Eli Bridge Company

Bulletin No.: 20190501-2

SAFETY ALERT

Ride Manufacturer: Eli Bridge Company **Affected Production Dates:** All Scrambler® Seats 35 years and older
Ride Names: Seats for Scrambler®, TMS® (Trailer Mounted Scrambler®) and 28' RS® Trailer Mounted Scrambler

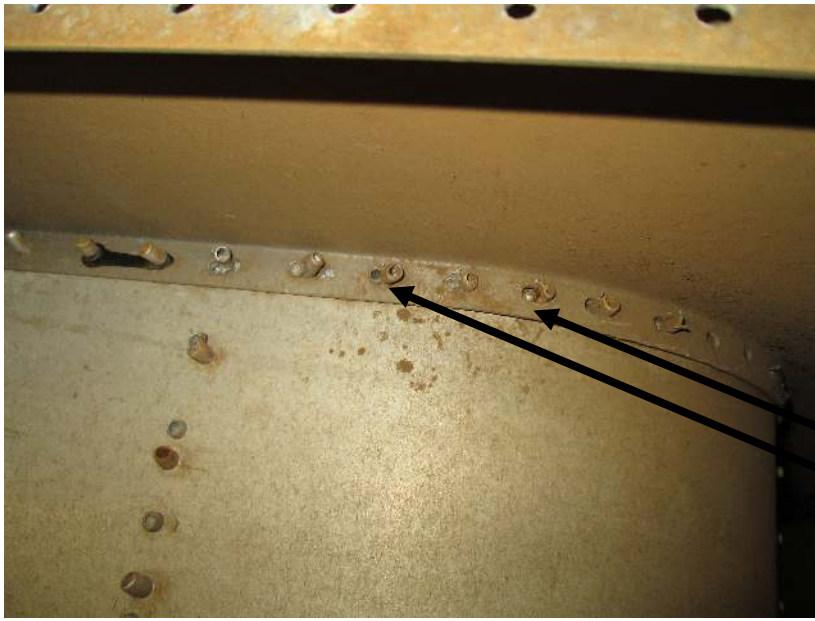
#1 It is obvious in the photo that new holes were drilled in the rib instead of properly aligning the holes in the skin with the holes in the rib. This causes the two holes to become a slot. New holes should NOT be drilled when replacing the skin. Call the factory if you have difficulties with this. The skin has misaligned holes as well from side to side. Both the skin and the flange must be replaced.

The misaligned holes caused slots to form which do not keep the rivets tight and take too much Material out of the flange.

#2 shows advanced corrosion on both the skin and the fasteners causing cracking around the fasteners. Notice too, the delaminating just to the right and below the fasteners on the right. This seat must be replaced.

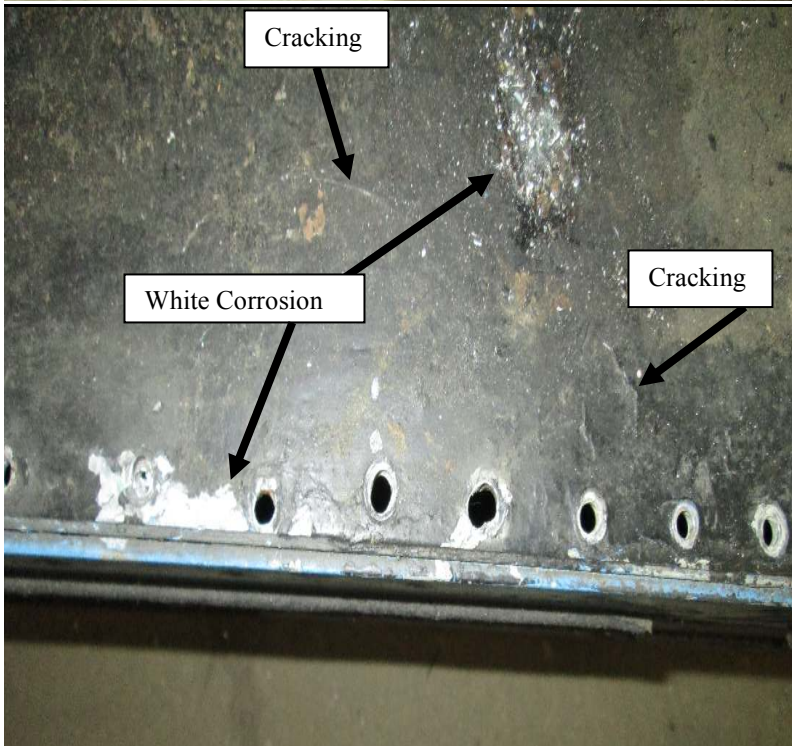
#3) shows multiple problems with corrosion and misaligned rivets. There should only be one line of rivets on the left side attached to the above skin. There should be no rivets on the side of the rib as are shown in this picture. There is also significant corrosion on the bottom of the skin. This seat must be replaced.

#4) shows several areas of white corrosion and misaligned holes such that some have become slots, which are unacceptable. The arrows show cracking on the skin, most likely from embrittlement. This seat skin must be removed and replaced. When the skin is removed, if the rib to which it was attached has holes like the ones shown and or corrosion, it must also be removed and replaced.
